APPROVED MINUTES OF THE MEETING

April 16, 2009

April 16, 2009	Project:	Bell Street Green Street Artist Designed Bike Parking New Bike Corrals
	Phase:	Briefing
	Last Reviewed:	N/A
	Presenters:	Robert Scully, DPD Gary Johnson, DPD Vaughn Bell, SDOT Doug Cox, SDOT

Project: **Children's Hospital Laurelon**
Phase: Street Vacation Step II – Public Benefits
Last Reviewed: 3/19/09; 4/2/09
Presenters: Allyyn Stellmacher, ZGF
 Todd Johnson, Seattle Children's Hospital

1. BURKE-GILMAN TRAIL / SAND POINT WAY NE CONNECTION AT HARTMANN SITE

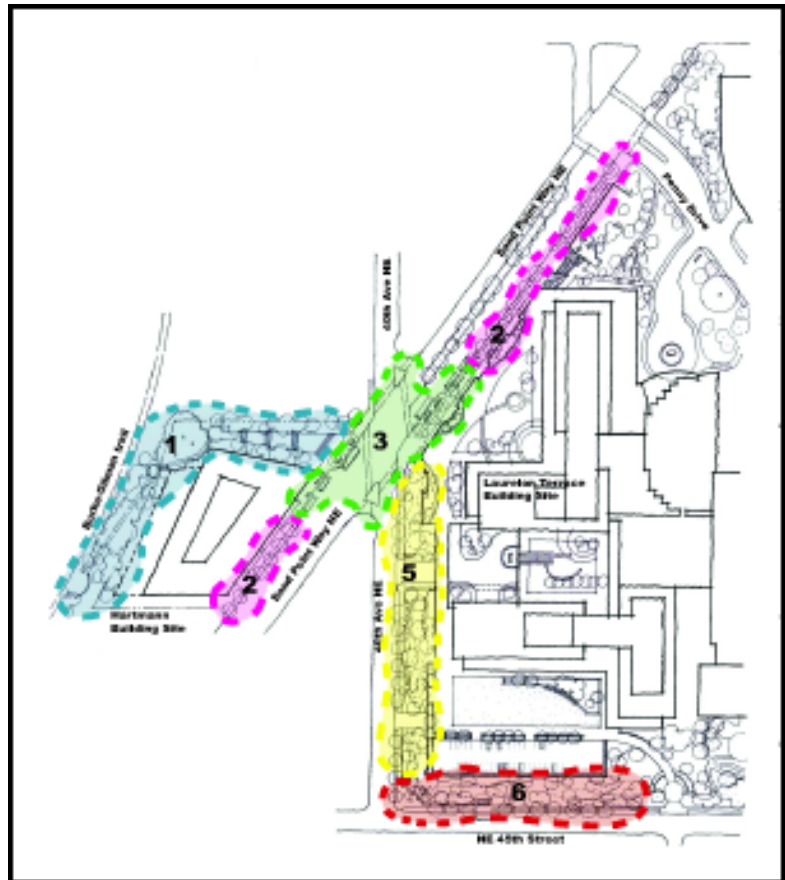
Public benefit item one, *Burke Gilman Trail / Sand Point Way NE Connection at Hartman Site*, in the packet submitted by the proponent is amended as follows:

- Clear sight lines from Sand Point to the Burke Gillman trail will be developed.

The path going from the trail to the steps, what kind of material are you using?

I'm curious about the grade changes on the trail as you arrive at various nodes, does it drop significantly?

In regards to the kiosk, I'm a little concerned about the area at the bottom of the stairs. It looks to me like there are too many things at the bottom of the stairs including the kiosk, signage and artwork.

Will the trail connection be accessible?

It will be some type of asphalt or concrete

About 30' of drop from the NE corner to the SE corner of the site.

Our intention is to provide ADA accessibility from Sandpoint Way to the Burke Gillman Trail.
